January 28, 2020

Over the past year, we have been building the Seacoast Reliability Project which is a new, 13 mile powerline from Madbury through Durham and Newington and into Portsmouth. In Durham, the powerline corridor where we are constructing this powerline, crosses through the Sandy Brook neighborhood. Once the construction is complete in the area, disturbed areas will be restored. In many cases, we've been working with landowners throughout the corridor to develop landscaping plans to assist with visual screening. The Sandy Brook Community Common Land (referred to as "Common Land") is one of those properties where we would like to develop a landscaping plan.

**SEACOAST RELIABILITY PROJECT  
DURHAM, NH  
SANDY BROOK DRIVE (WEST)  
LANDSCAPE MITIGATION PLAN**

**SEACOAST RELIABILITY PROJECT  
DURHAM, NH  
SANDY BROOK DRIVE (EAST)  
LANDSCAPE MITIGATION PLAN**

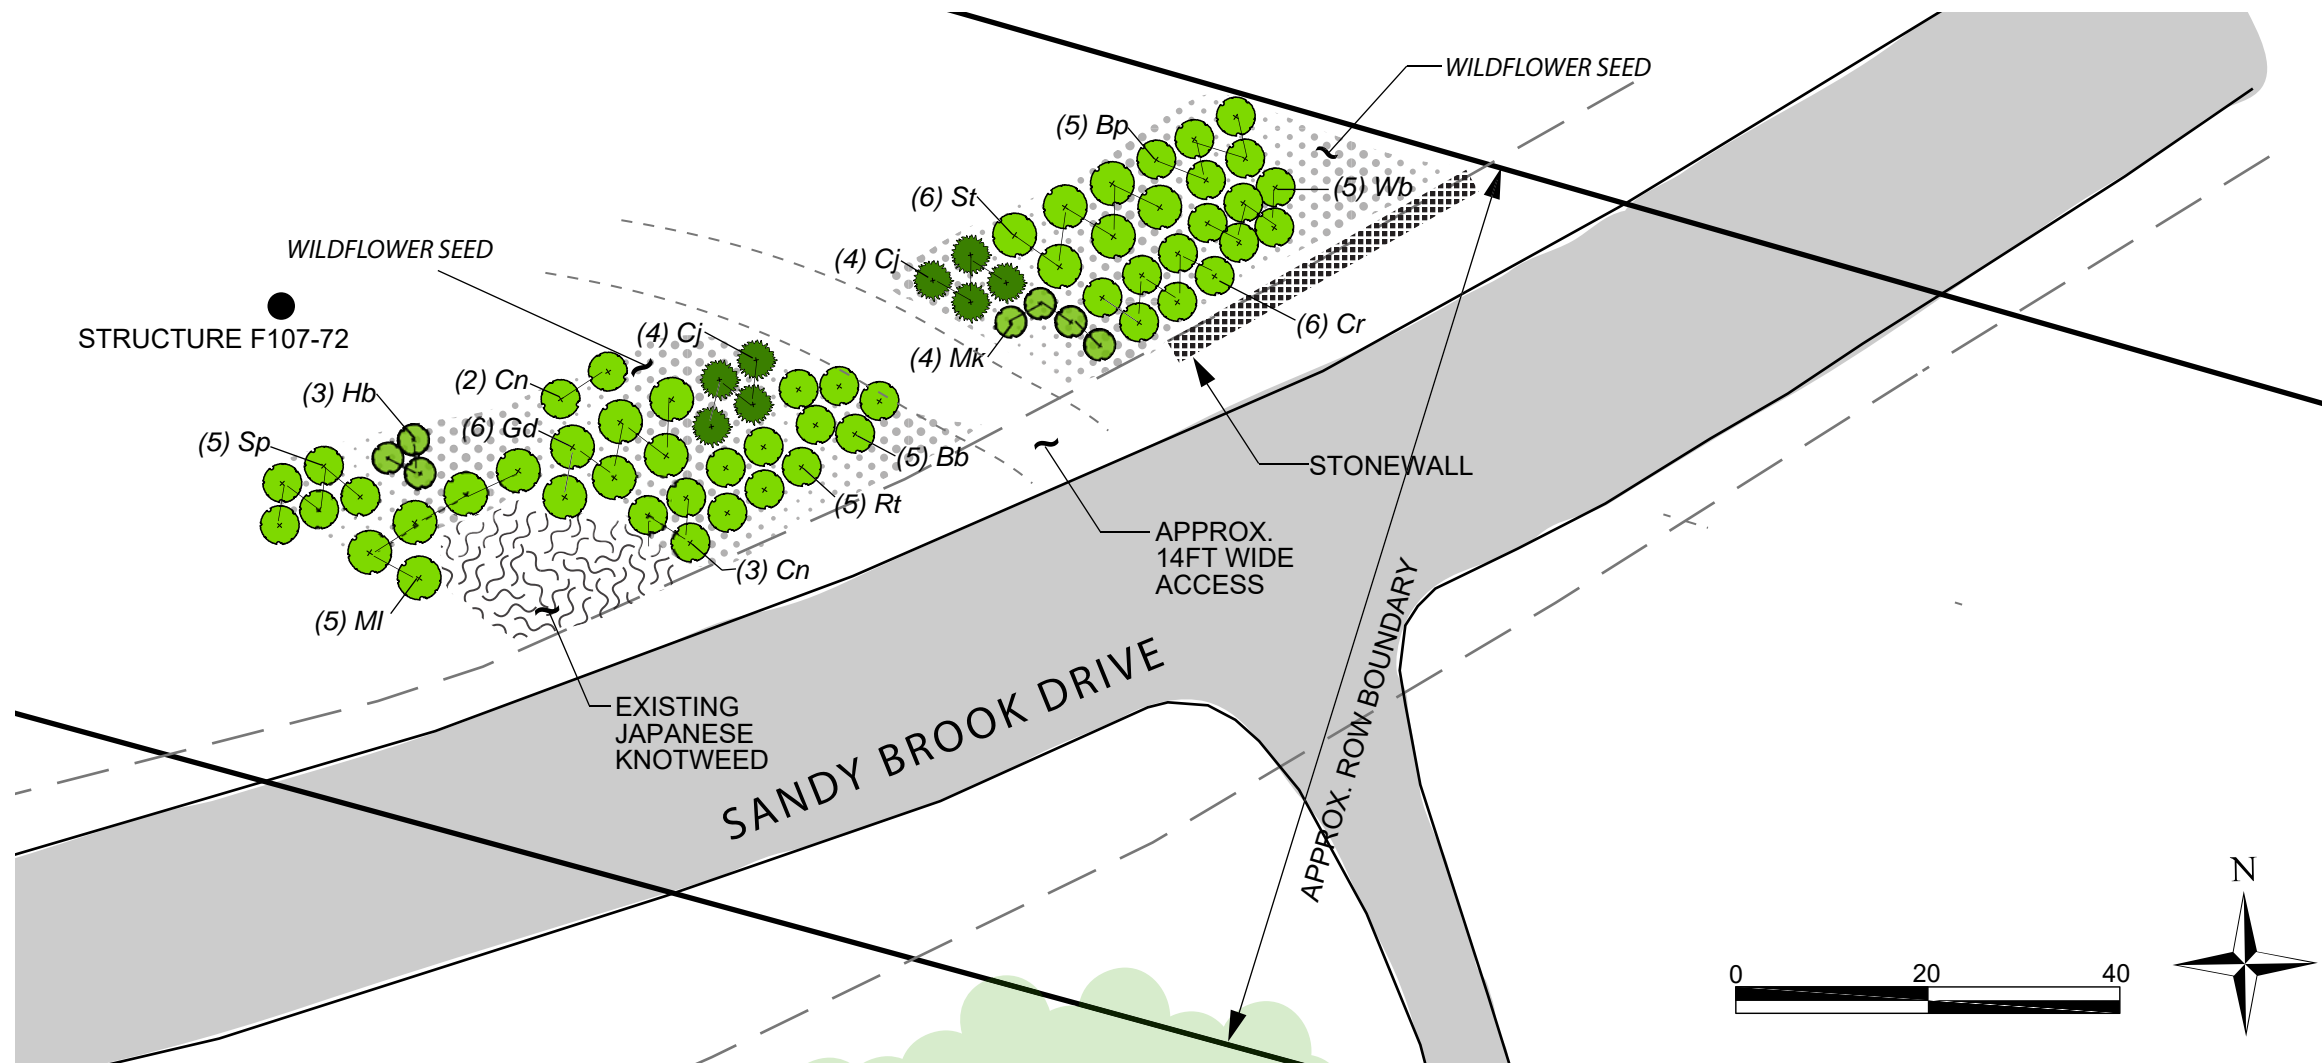
In the Initial Plan, a willow fence was proposed near a wetland in the interior of the Common Land and is a significant distance from the roadway. With the fence proposed so far into the powerline corridor it would be minimally visible from Sandy Brook as a visual buffer and therefore we recommend the willow fence be moved closer to the road to provide a more effective visual buffer. This change is reflected in the Proposed Plan.

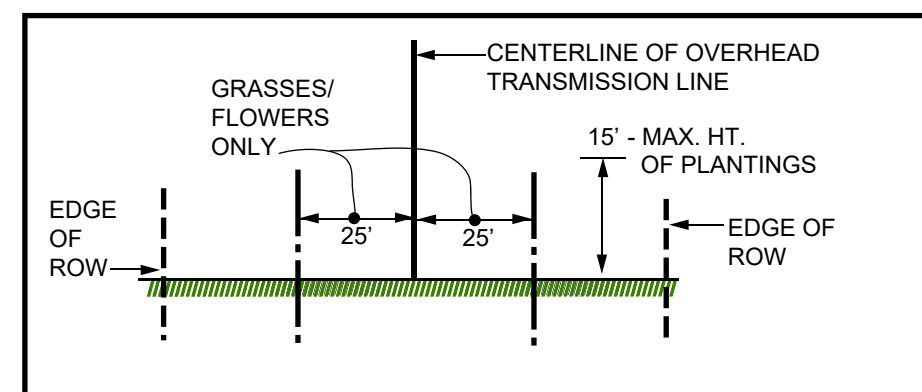
Taking this into consideration, our arborist and landscaper reviewed the Initial Plan and found that some of the preferred plants include species that are not native to the existing plants in the Common Land, such as the Lilac variety, Juniper species and Smokebush. While these plants were included on the list of compliant plants in the powerline corridor provided to the Sandy Brook neighbors at the October 22, 2019, site meeting, these are typically better suited for a maintained residential property as compared to a wooded area.

In the Initial Plan, the wildflower seeding was proposed in a location further down the powerline corridor with limited visibility from Sandy Brook Drive. To increase the chances of survival and visibility of the wildflowers, we propose relocating the wildflower seeding from further down the powerline corridor to closer to the road among the proposed new plantings. In addition, it would reestablish resources for pollinators and other beneficial wildlife. Both the slight variation in wildflower seed mix and relocation are reflected in the Proposed Plan.

To increase the survival rate of the plants and the effectiveness of creating a visual buffer from the roadway, we recommend replacing the species above with Common lilac (*Syringa vulgaris*), Arrowwood Viburnum (*Viburnum dentatum*), Bayberry (*Myrica pensylvanica*), Silky Dogwood (*Cornus amomum*), or Chokeberry (*Aronia arbutifolia*) as substitute species more suited to the wooded location. While we recommend this species revision to the Initial Plan, it's not reflected in the Proposed Plan due to our attempt to keep the plan as close to the Initial Plan as possible; however, we ask that these revisions are considered by the neighbors.
